RECALL 25V425 / 2025-343 REMEDY INSTRUCTIONS

FOREST RIVER	Make(s): SALEM & WILDWOOD Model(s): ROOST43 Model Year(s): 2025 - 2026	Repair Code: RC-034-09-00-004727 Allotted Time: .25 Inspection Code: N/A Allotted Time: N/A
	Concern: The entry patio door, which is the main egress, may have an exterior transit latch which may not be operated from inside the vehicle if locked.	Photo(s) Required: NO Prior Authorization Required: YES Part(s) Kit Number: F100763300 Part(s) Return: NO, FIELD DESTROY

FIGURE 1 – REMOVE FASTENERS/BUMPER/BRACET

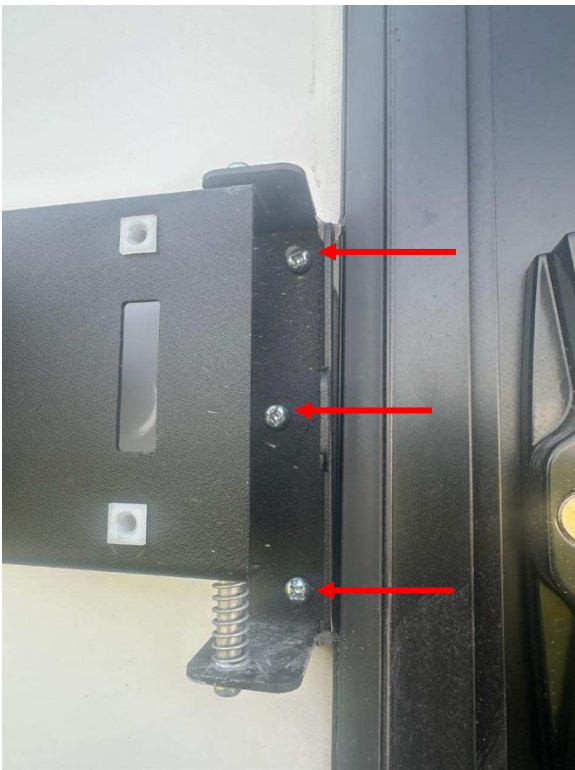
STEP 1: LOCATE THE TRANSIT LATCH, RUBBER BUMPER AND REMOVE (FIGURE 1)

- KEEP THE THREE FASTENERS FOR USE LATER;
- SCREWS HAVE RED ARROWS IN FIGURE 1;
